# CLERMONT COUNTY OHIO

## PLANNING COMMISSION STAFF REPORT

FOR CONSIDERATION BY PLANNING COMMISSION ON May 20, 2025

### SHAWNEE STATION – DESIGN PLAN

DRAWN BY:	SEAL
CHECKED BY:	JCK
PROJECT MANAGER:	SPM
PROJECT NO. 24-185	
SCALE 1"=100'	
DATE 04-25-25	
ZONE CHANGE PLAN	
SHEET	C-400

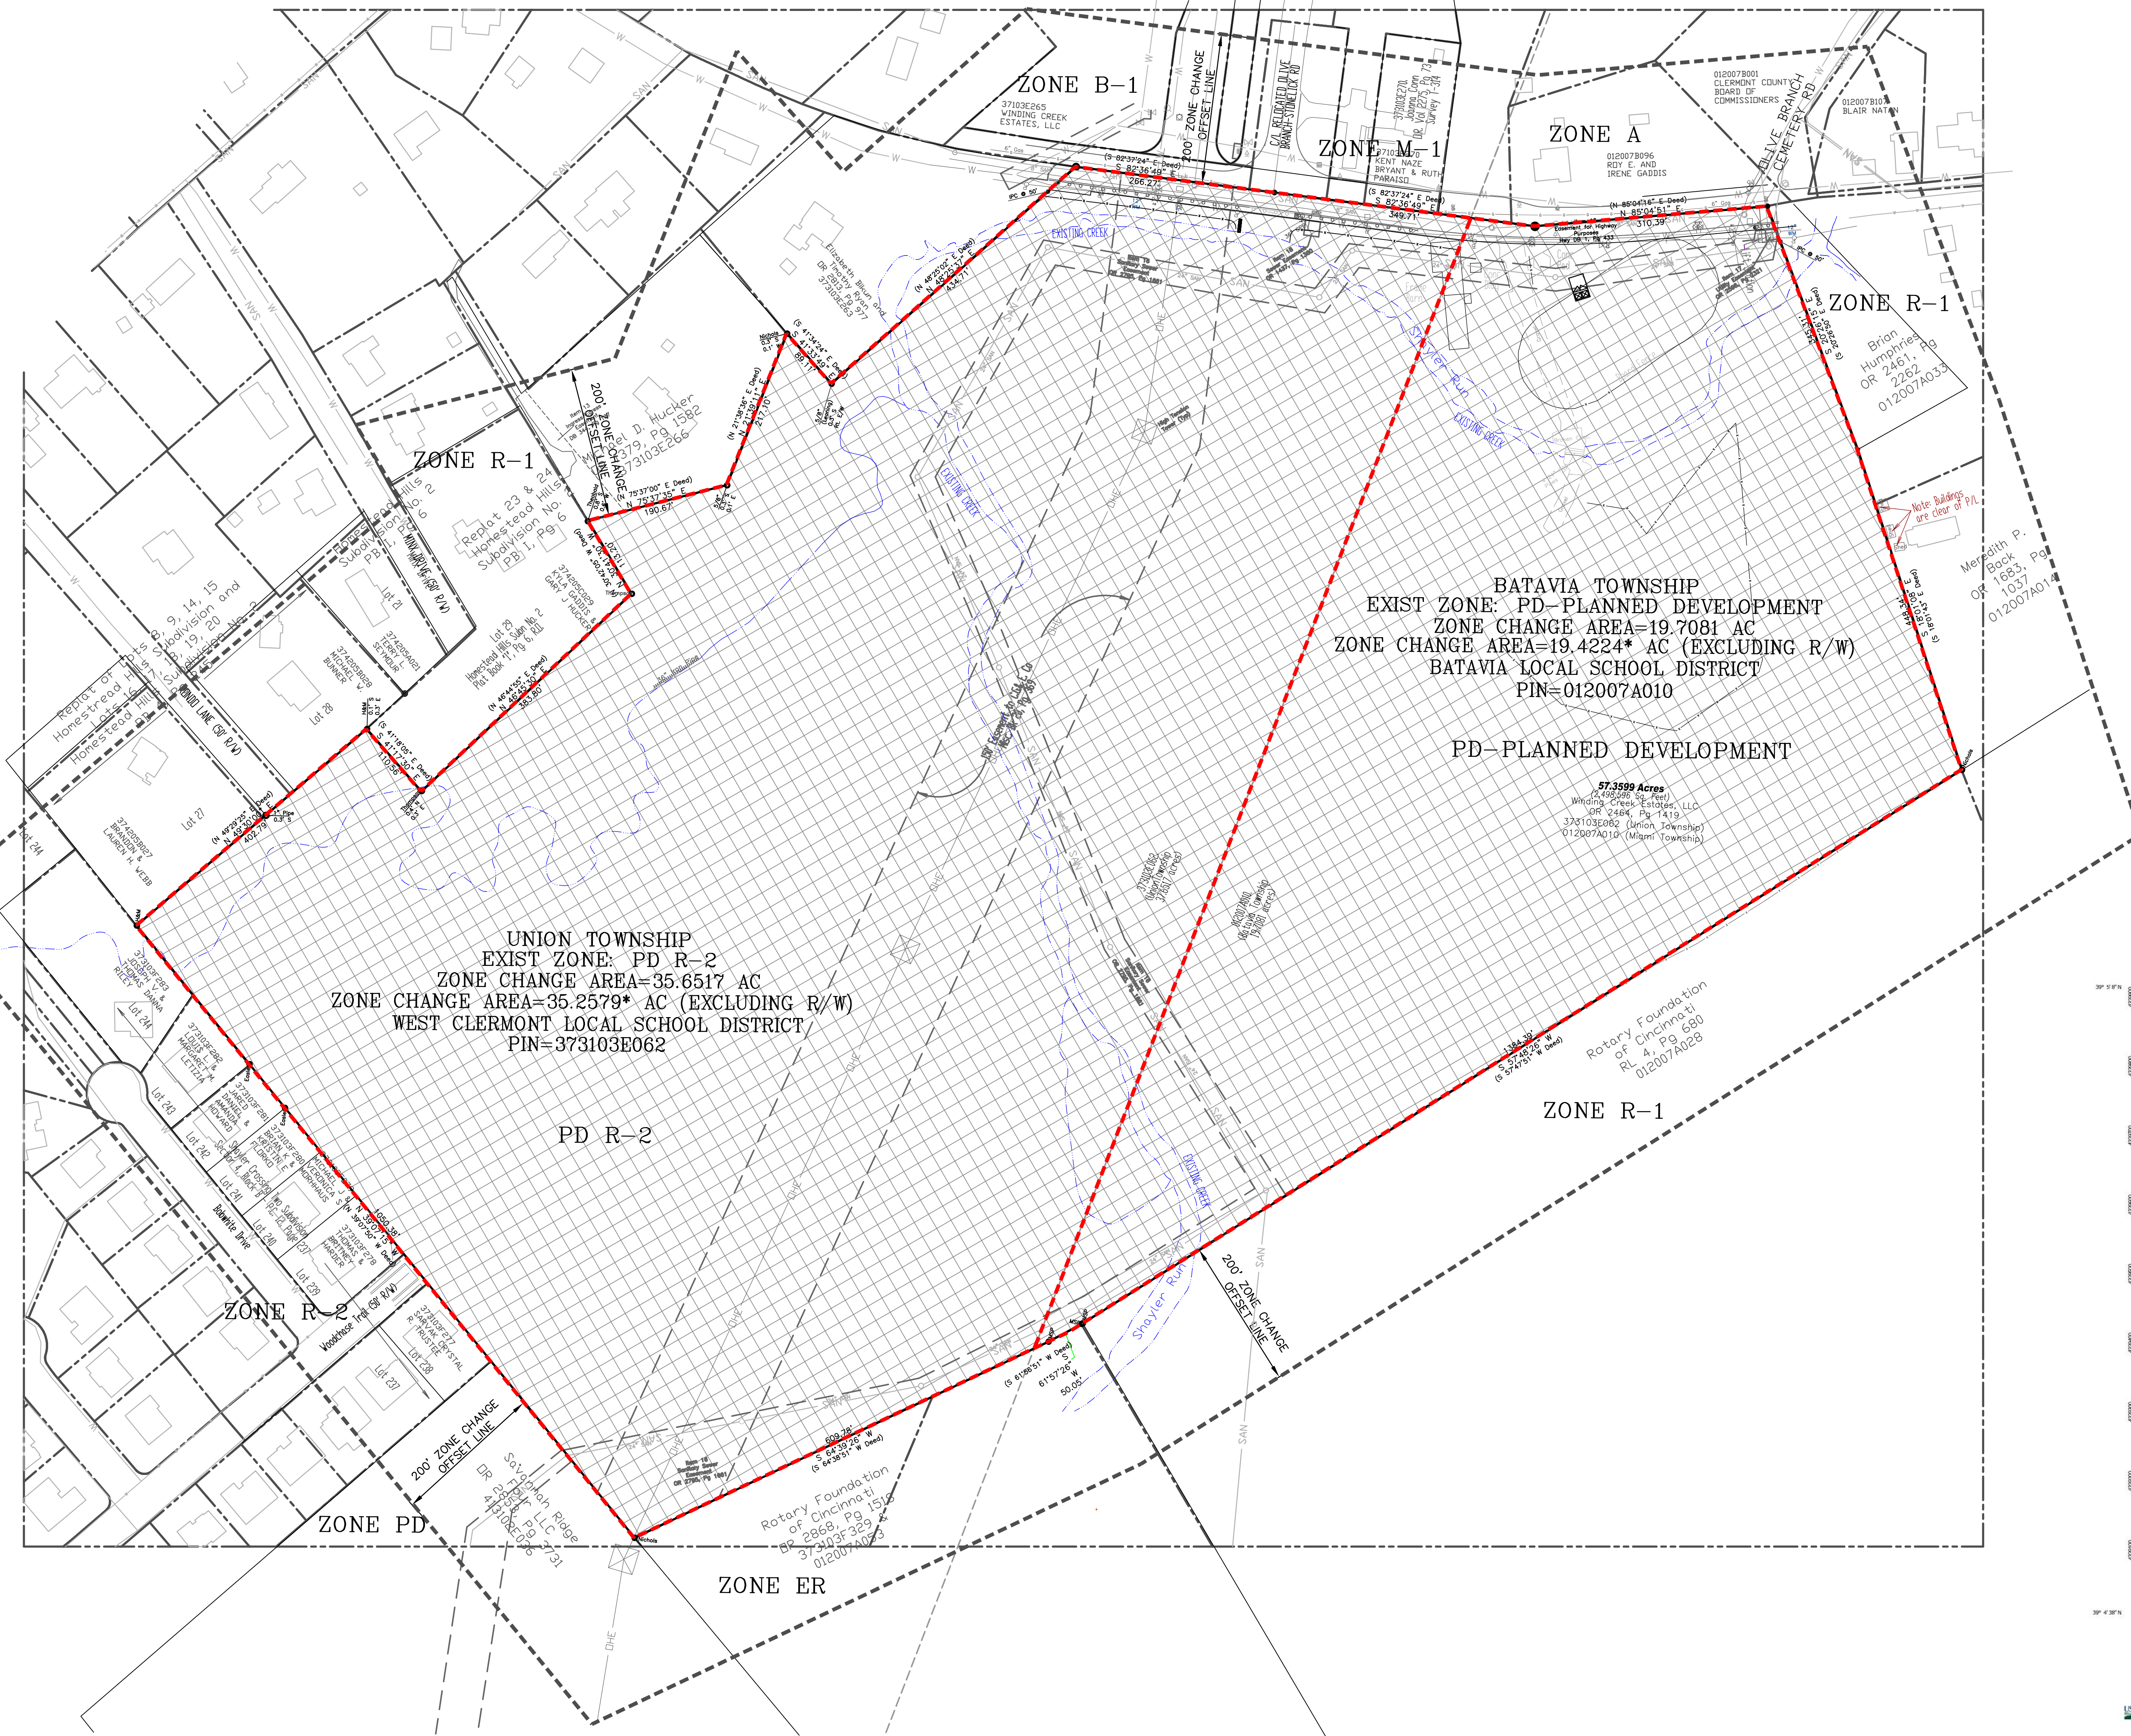
1. Sheet C-400, Sanitary Sewer laterals are not shown on the plans for each residence with the appropriate cleanouts per CCWRD rules and regulations, specifications, and details.

2. Sheet C-400, Sanitary Sewer appears to be short near the cul-de-sacs and will cause longer than acceptable laterals through the cul-de-sacs. Keep laterals less than 100 feet within the public R/W & easements (sanitary sewer to public cleanout).

3. Sheet C-400, Sanitary Sewer
4. Provide appropriate General Notes from CCWRD rules and regulations, specifications and detail sheets for the water and sewer.
